LICENSE AMENDMENT REQUESTS DATED July 11, 1994 Fire Protection Technical Specification Changes

EXHIBIT B

Operating License and Technical Specification Marked Up Pages

TS.	3,14	-1		
PEU	01	10	127	180

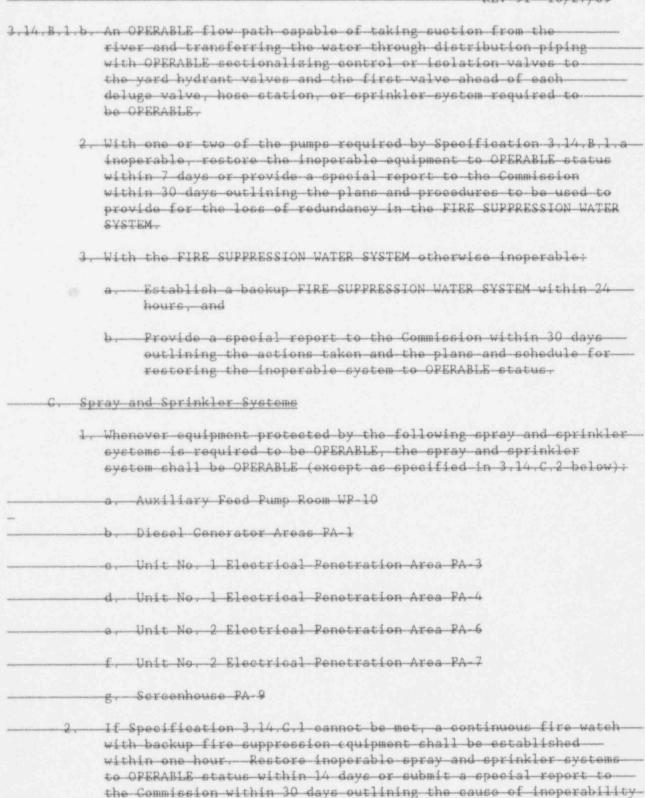
3.14 FIRE DETECTION AND PROTECTION SYSTEMS

- 1. The minimum fire detection instrumentation for each fire detection zone shown in Table 3.14-1 shall be OPERABLE whenever equipment in that fire detection zone is required to be OPERABLE (except as specified in 3.14.A.2). Fire detection instruments located within containment are not required to be OPERABLE during the performance of Type A containment leakage rate tests.

- 2. If specification 3.14.A.1 cannot be met;
 - a. Within one hour, establish a fire watch patrol to inspect the some with the inoperable instruments at least once per hour. Fire some located inside primary containment are exempt from this requirement when CONTAINMENT INTECRITY is required.

- b. Restore the inoperable instruments to operable status within 14 days or submit a special report to the Commission within 30 days outlining the cause of the malfunction and the plans for restoring the instruments to OPERABLE status.

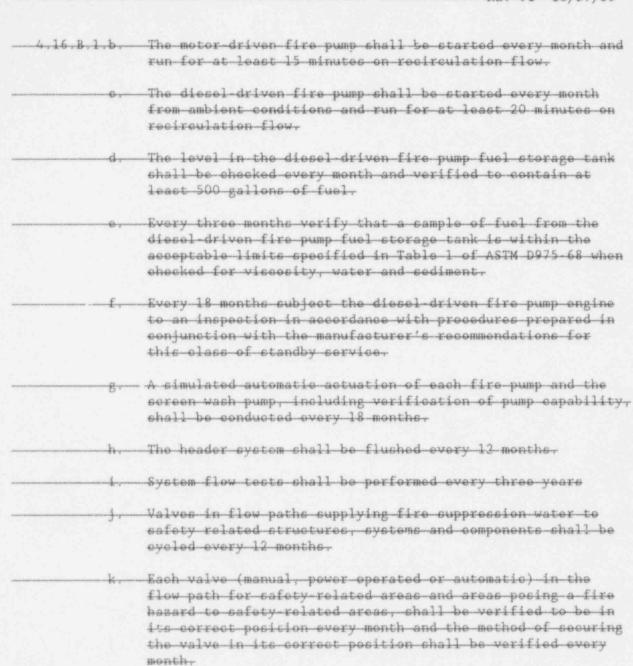
- Fir	e Detection, Instrumentation
1,	The minimum number of fire detectors required in each zone specified in Table TS.3.14-1 shall be functionally tested once every six months. The minimum number of fire detectors required in areas which are inaccessible during operation shall be functionally tested during each cold shutdown exceeding 24 hours unless performed during the previous six months, however, the outage need not be extended solely for completion of these tests.
2,	The alarm circuit for the detectors required in each zone specified in Table TS.3.14-1 shall be tested every six months.
. Fir	e Suppression Water System
-1.	The system shall be verified operable as follows:

a. Operability of the diesel-driven fire pump starting battery shall be demonstrated by:
	1. Once each week verify electrolyte level and voltage is within specification.

2. Once every three menths verify the specific gravity of each cell is within specifications.
	3. Once every 18 months inspect the batteries, battery racks, and electrical connections for damage or
